PRELIMINARY PLANNING PROPOSAL, 3 – 31 WALTER STREET & 462 WILLOUGHBY ROAD, WILLOUGHBY

The following responds to the Urban Design Review of the above planning proposal prepared by Architectus for Willoughby City Council dated 4 August 2017. The Urban Design Review has been used to amend the preliminary planning proposal, indicative masterplan concept and landscape masterplan for consideration by Willoughby City Council.

South of Walter Street ownership Patterns

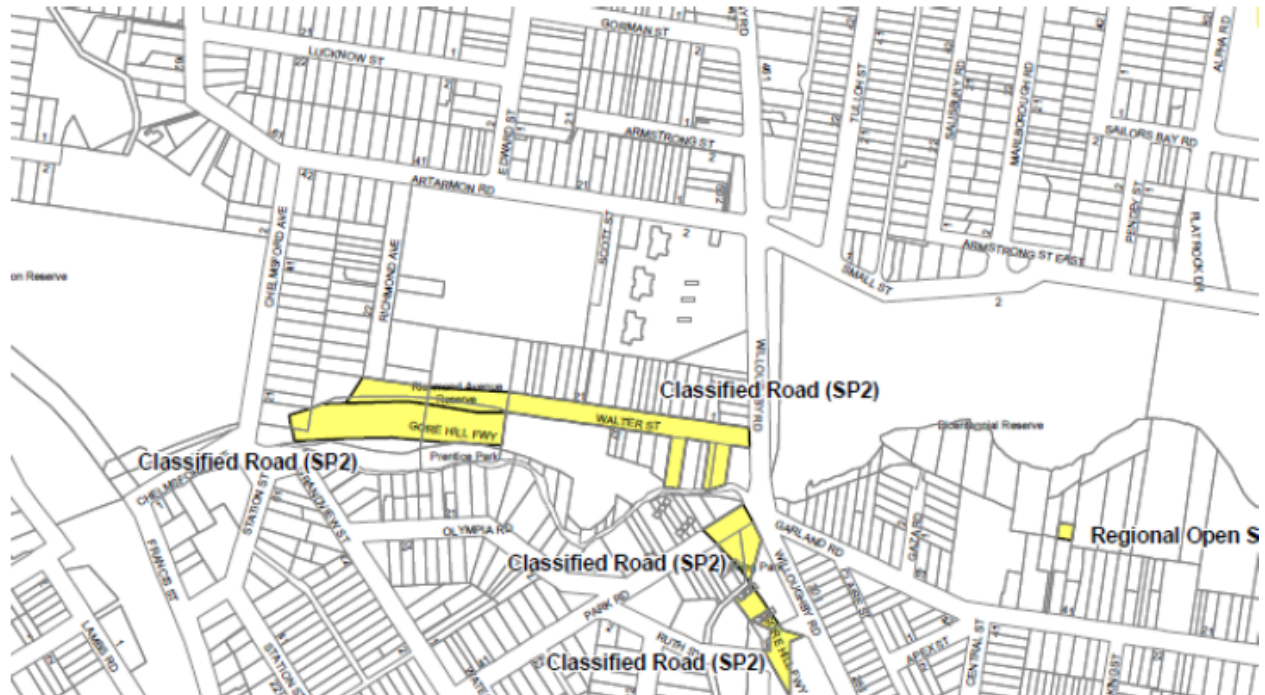
- c. The demonstration of cross ventilation testing for the built form to support the analysis at Section 4.2.9 of the Walter Street Design Report; and*
- d. Consideration of a potential future character of land to the south of Walter Street.*

It is noted that the land to the south of Walter Street (Point 3(d)) is zoned SP2 in relation to the Gore Hill Freeway and the majority of the properties are in ownership of Roads and Maritime Services as reflected on the aerial photograph below. The properties which remain in private ownership are nominated under the Willoughby LEP for Land Acquisition for road purposes. It must be assumed that this land will have a future potential road related function.

Proposed Maps

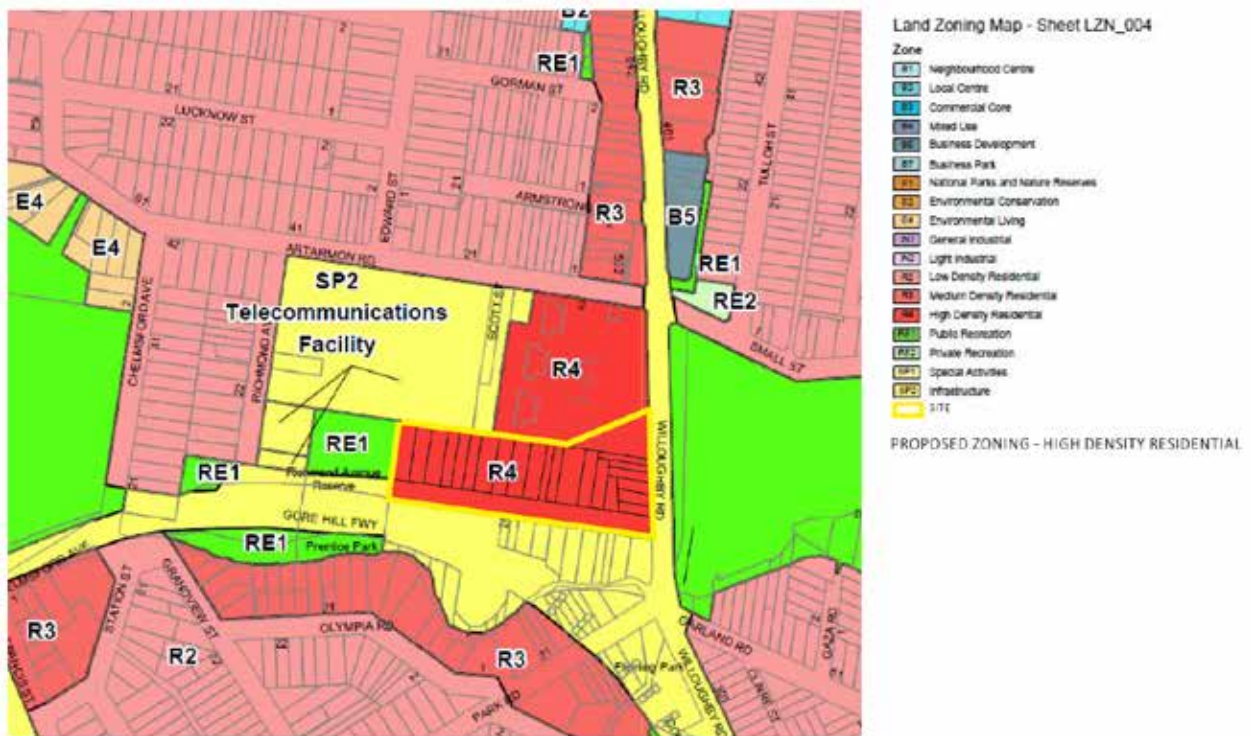
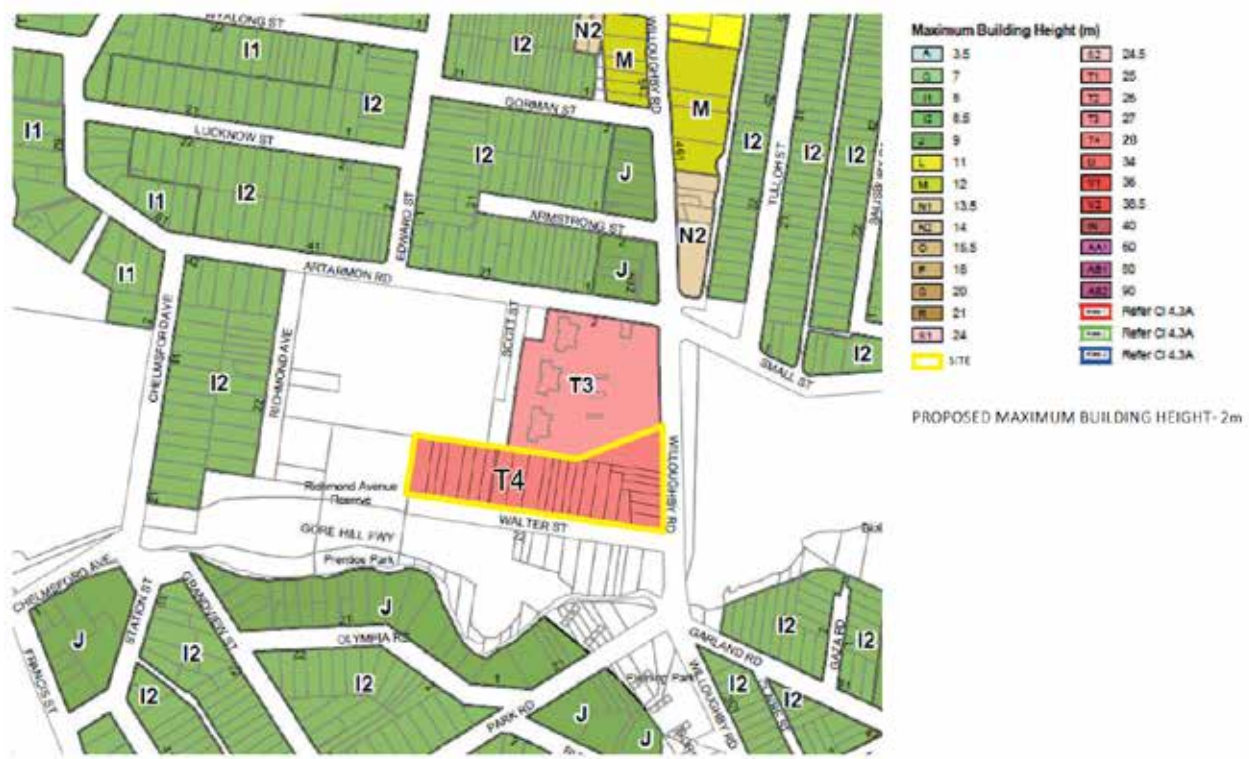
- 4. 1A Walter St and 450-460 Willoughby Road should be removed from the proposed amended LEP mapping, given no testing has been undertaken to demonstrate the capacity of these sites to achieve the proposed height and FSR;*

The Proposed Mapping has been amended to exclude the 450 – 460 Willoughby Road and 1 Walter Street consistent with Point 4.

5.2.7 STREET ELEVATION

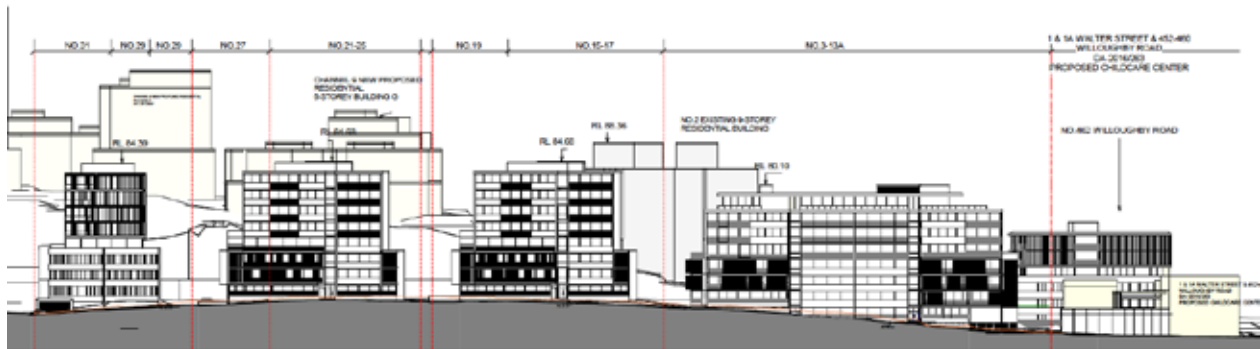
- 6. The built form in the indicative master plan requires further consideration. An alternative built form is proposed to better respond in detail to the context and character of Walter Street and Willoughby Road, particularly for Sites A and E. The built form proposal needs to respond to the predominant stepped typology of the block, with a lower street wall (three-storeys) and reduced scale to Willoughby Road and single dwellings to the south of Walter Street.*

- 7. Subject to the further testing recommended in the comments above, Architectus feel that a maximum height of buildings control in the WLEP 2012 that facilitates a built form of up to eight-storeys on Sites B – D, seven-storeys (six plus penthouse) for Site A, and four-storeys (three plus penthouse) for Site E could be appropriate for the site (refer to Figure 11).*

The proposal has been amended to provide a stepped built form with a lower street wall height of three storeys and a reduced scale to Willoughby Road and to the single dwellings to the south of Walter Street consistent with Point 6. The amended form achieves eight storeys on sites B – D and seven storeys (six plus penthouse) on site A and four storeys (three plus penthouse) on site A consistent with Point 7.
